ARCHITECT'S SUPPLEMENTAL INSTRUCTIONS

PROJECT:	The Reserves at South Lake New Apartment Complex Grinnell, IA	Report No.	Three (3)
OWNER:	OPG South Lake Partners, LLC Dan Maximuk 234 N. Santa Fe Ave, Suite A Salina, KS 67401	Date	January 18, 2022
CONTRACTOR:	MCP Group 3501 SW Fairlawn Rd. Topeka, KS 66614	Architect's Proj No.	20-3118
		Contract For:	General Construction Mechanical, Electrical

IFA Plan Review

A3.3

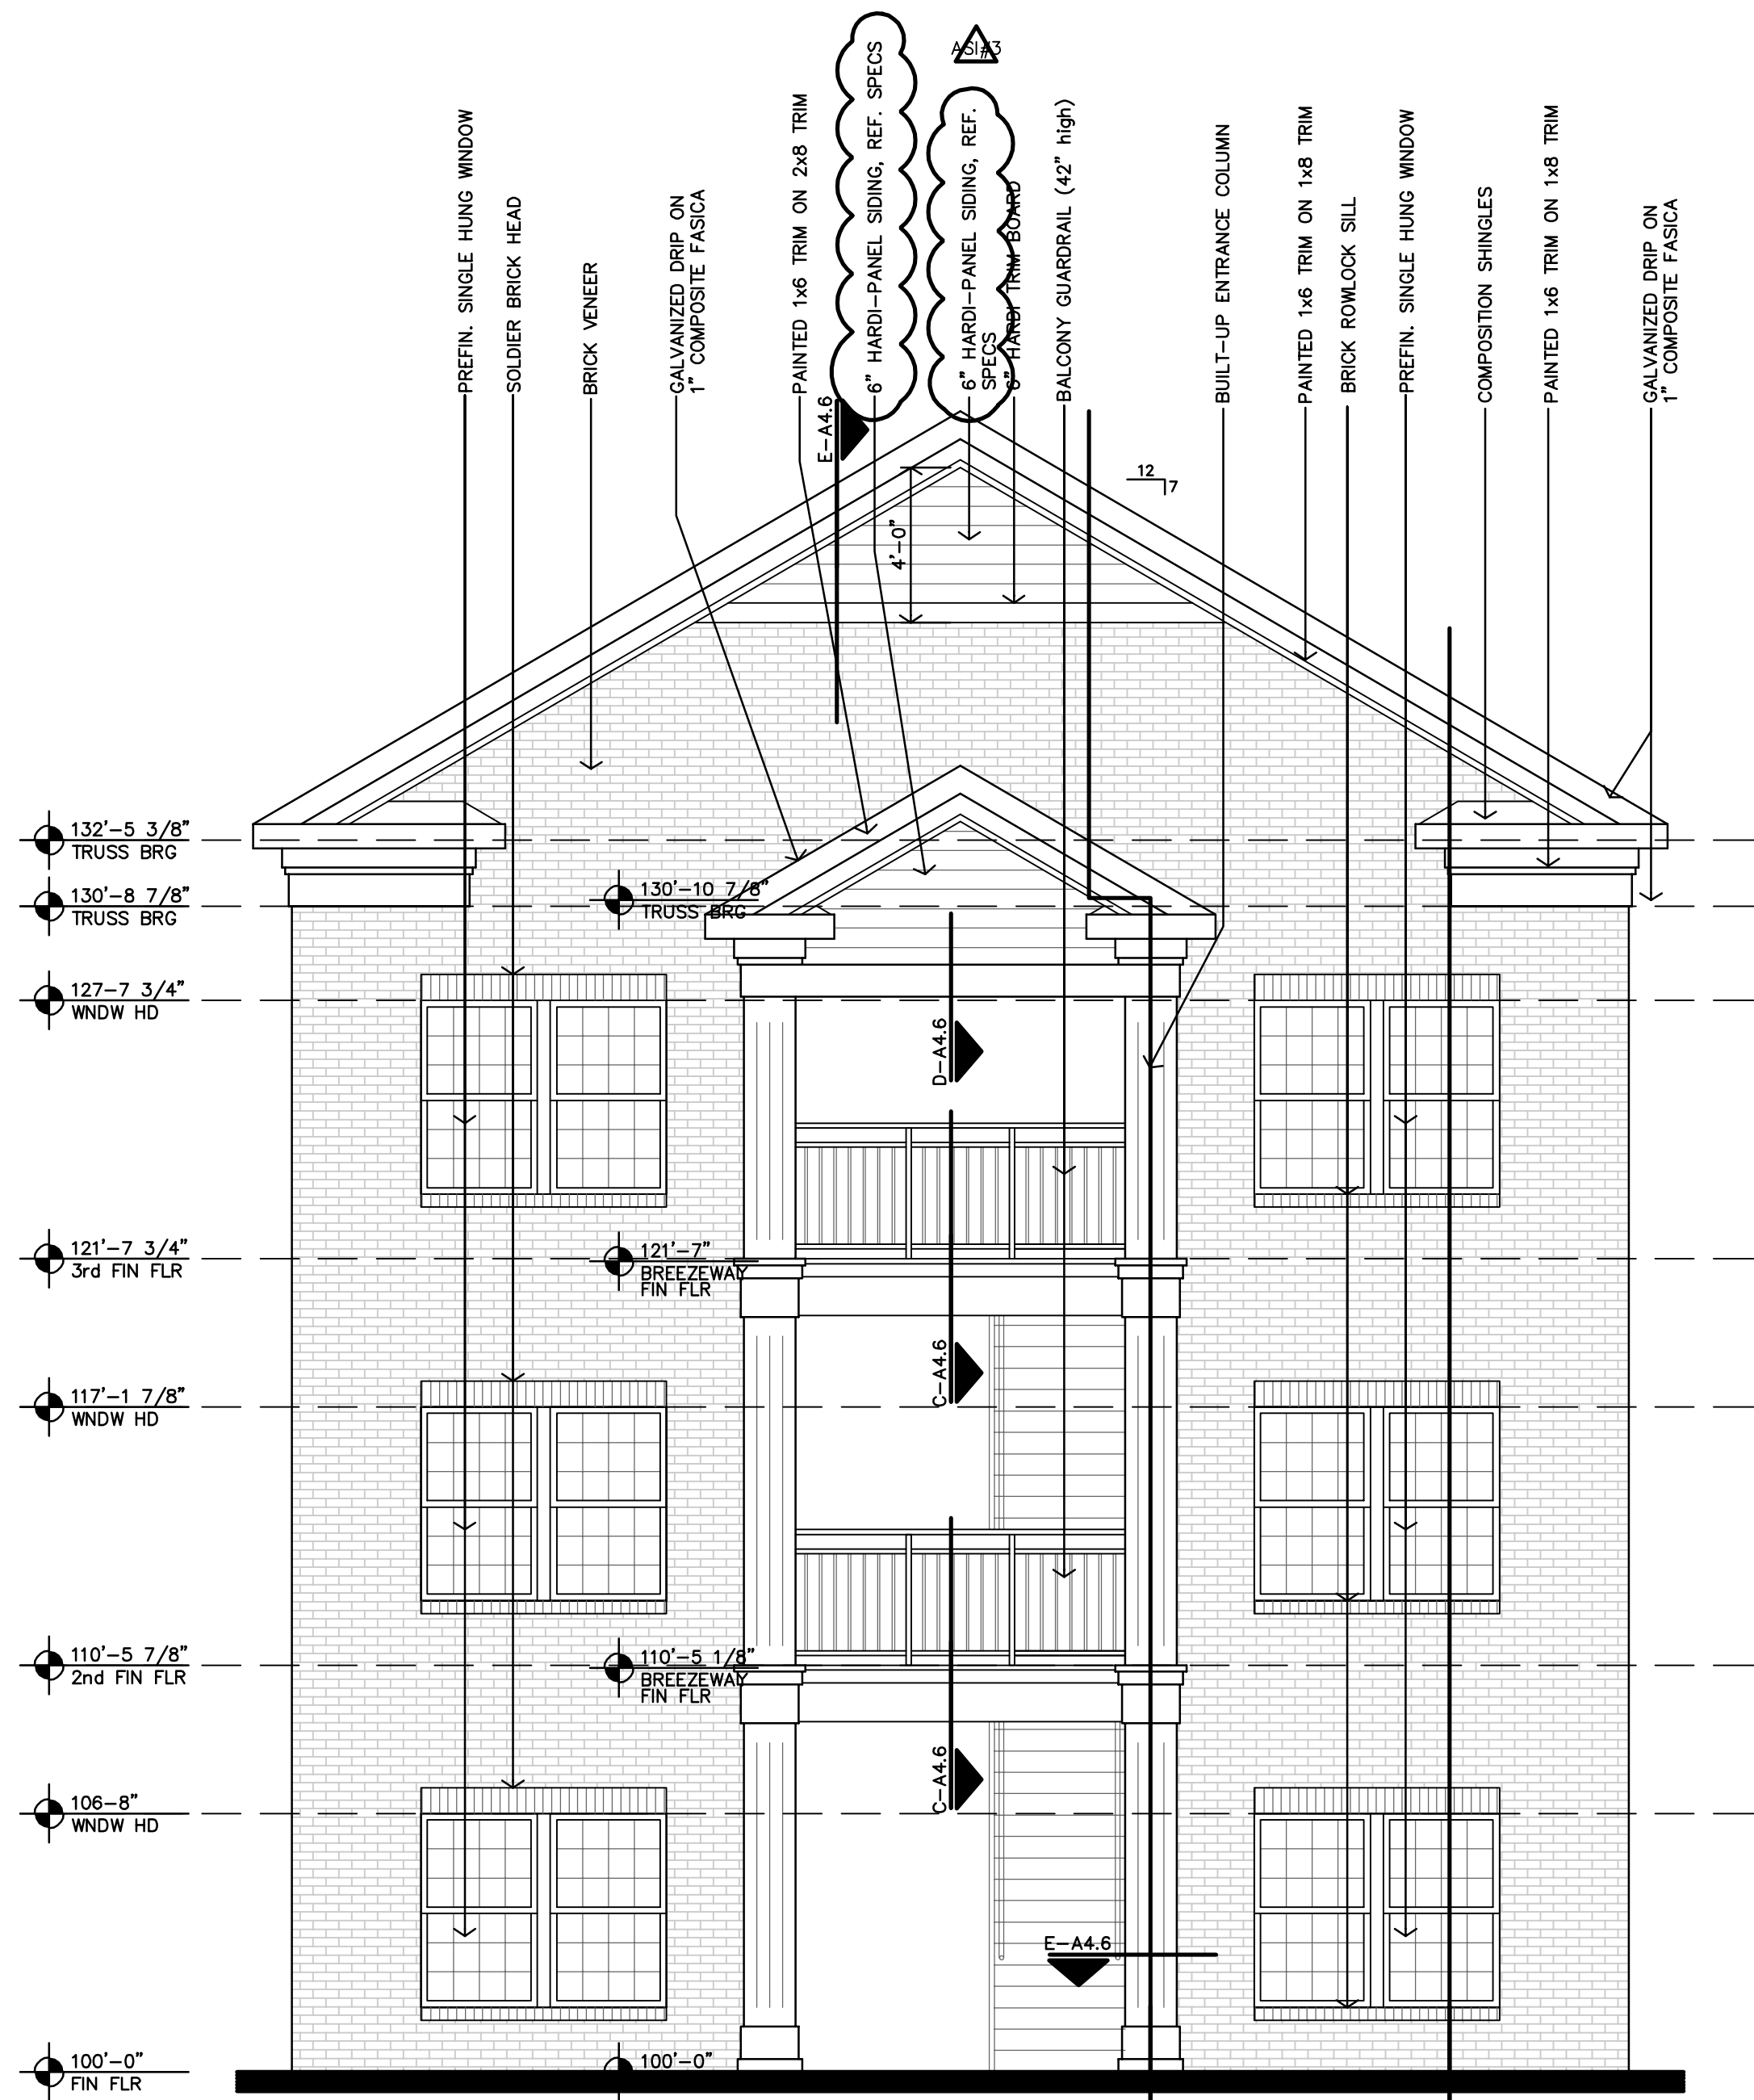
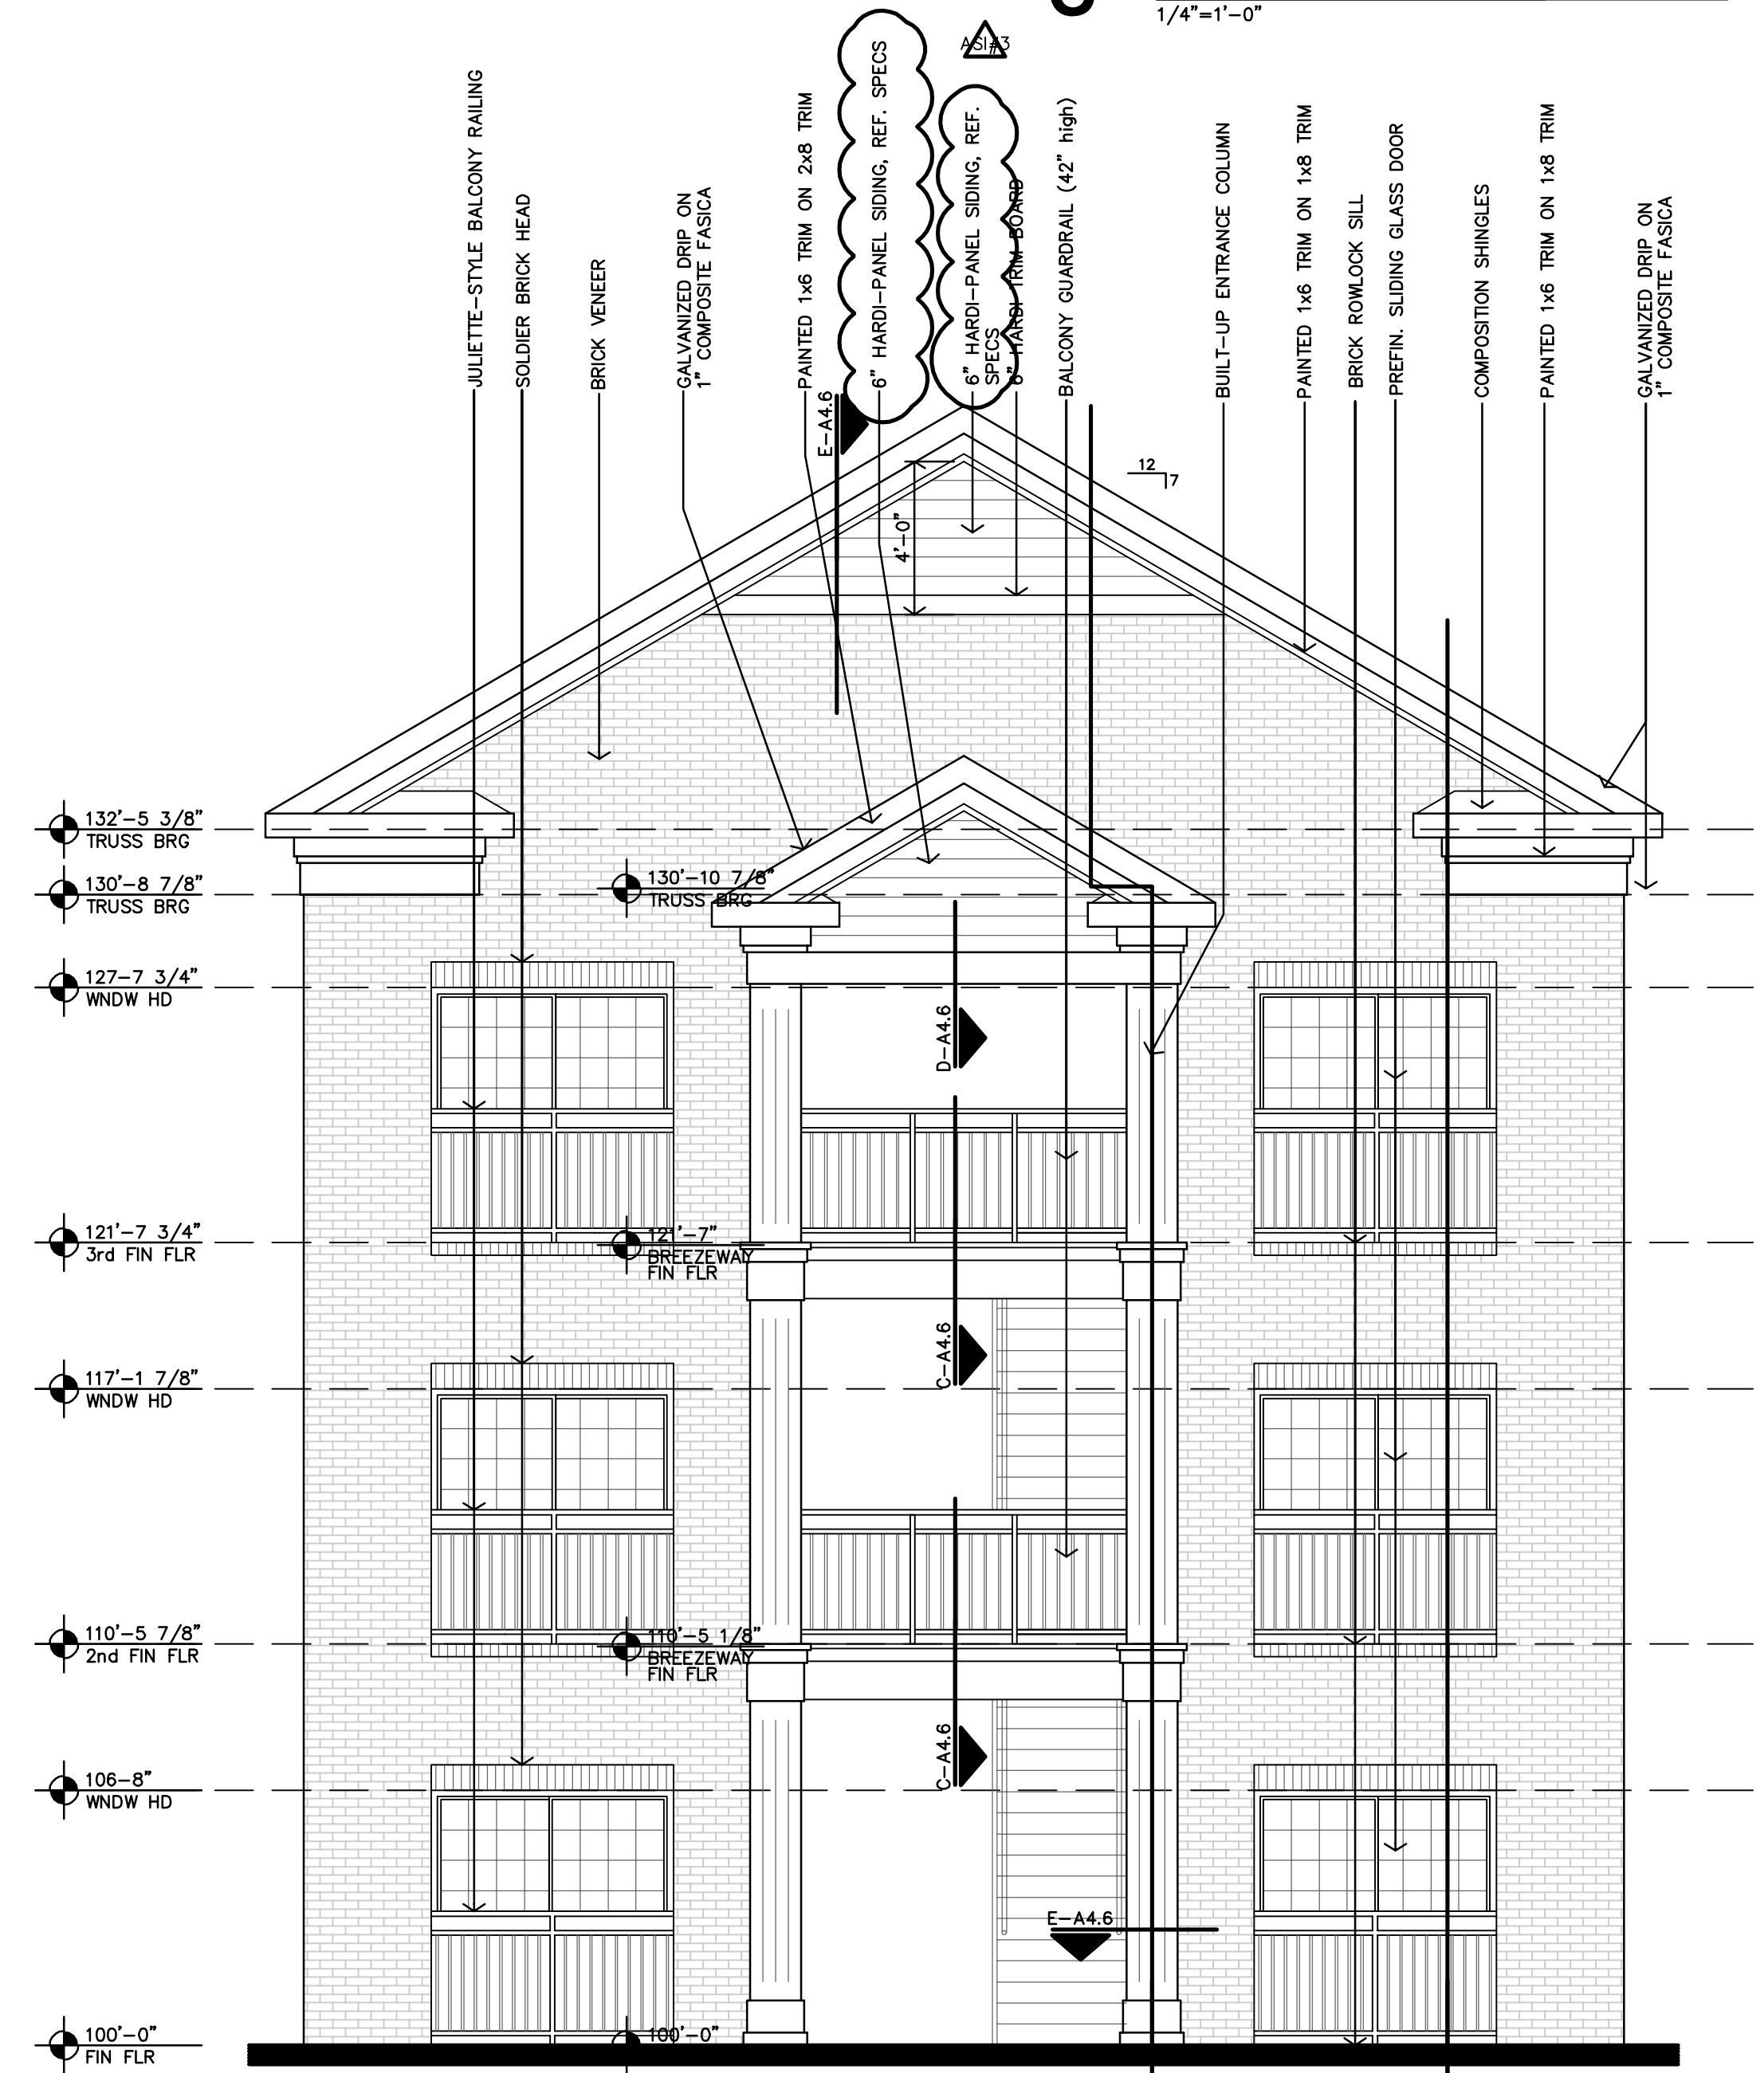
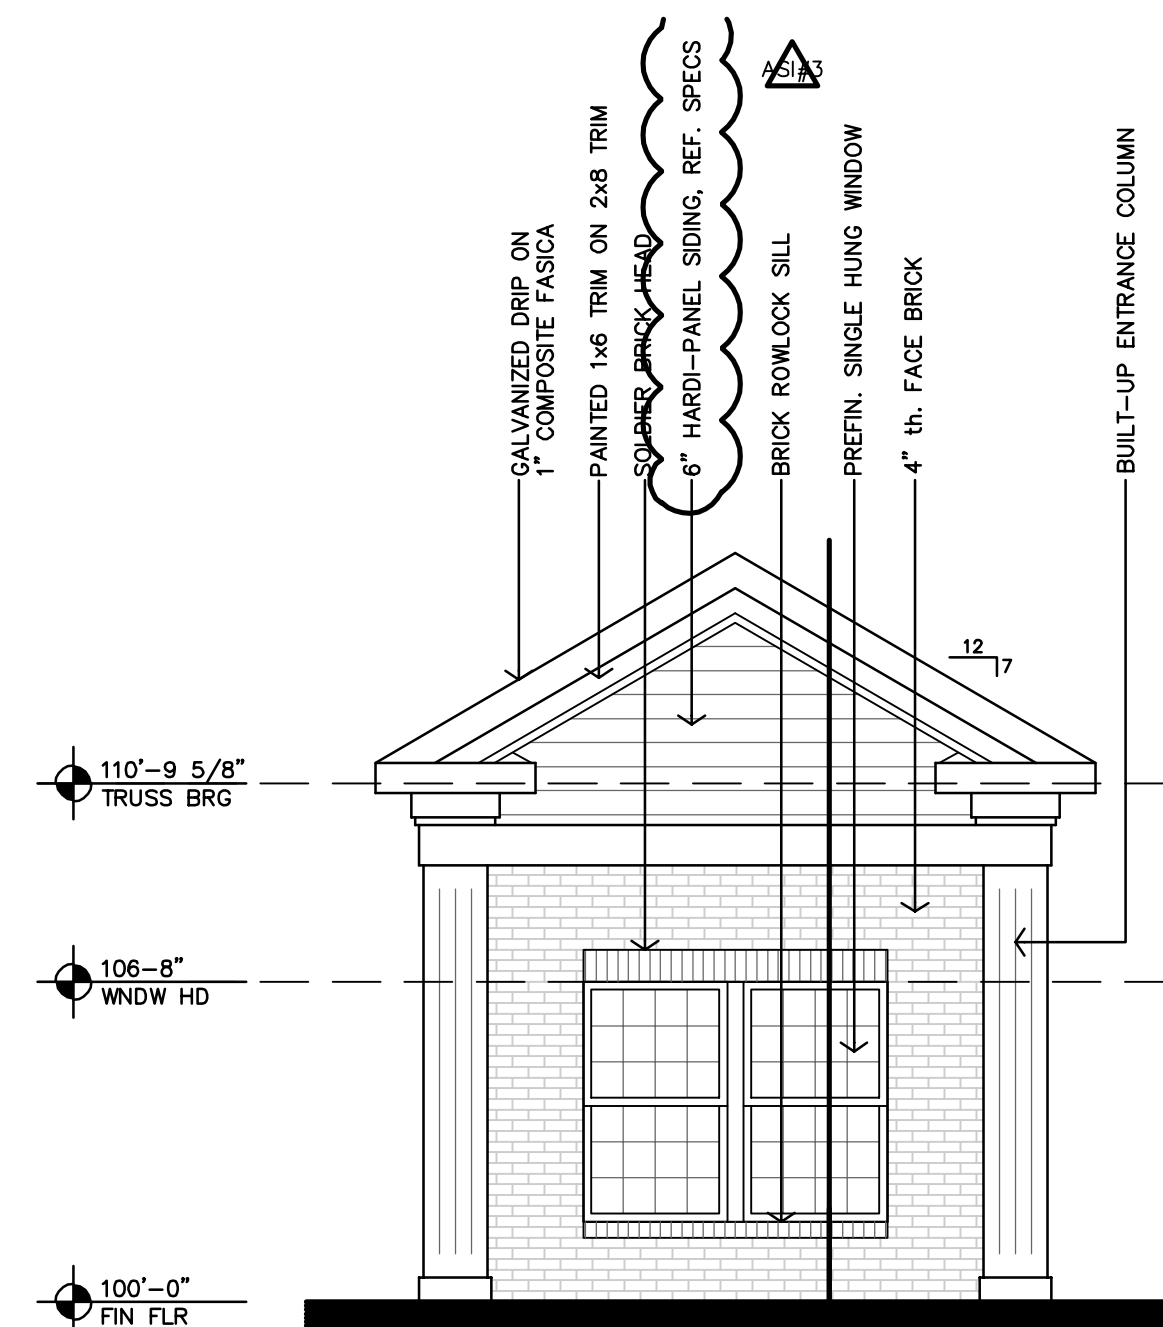
- iv. Sheet A2.10 – Apartment Building A Summary has been corrected
 - v. Sheet A2.11 – Apartment Building B Summary has been corrected
 - vi. Sheets A3.1-A3.3 – notes have been changed to read “hardi-panel siding” in lieu of composite siding

6. Elevations indicate "composite siding". Verify this is the Hardie siding called out in the specs. The only composite siding acceptable for points is Smart Board by LP. Specifications indicate that James Hardie Fiber-Cement Siding shall be used. Elevations have been revised to read "Hardi-panel" in lieu of composite siding. Reference attached specification and Sheets.
